Access Compliance Report

Public Rights-of-Way

| Intersection ID: N/A | Main Street: GANNON_DR | Cross Street: RACHEL_FREEMAN_WY | Location: SE |
| ADA ID: 3F15447739C1 | Ramp Type: Perp | Initial Pass/Fail: Fail | Overall Compliance: No |

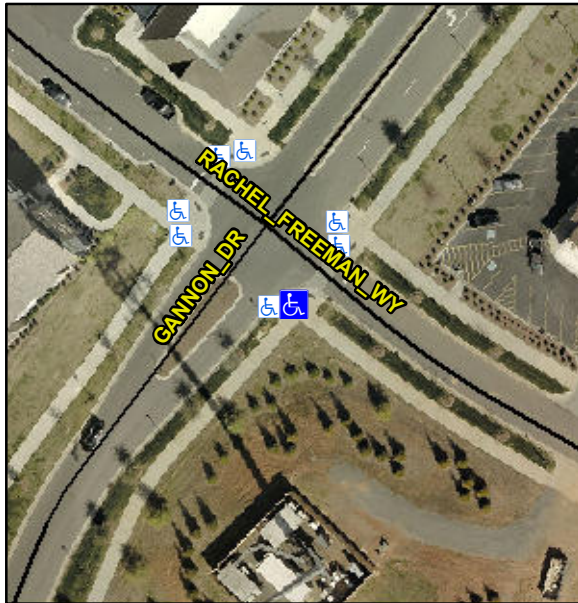
Not Found, R304.2.2

| Compliance | Description | Data | Compliance | Description | Data |
|------------|-----------------------|-------|------------|-----------------------------|------|
| N/A | Ramp Length (in) | 98.5 | No | Ramp Slope (%) | 9.7 |

Remove & Replace Entire Ramp.
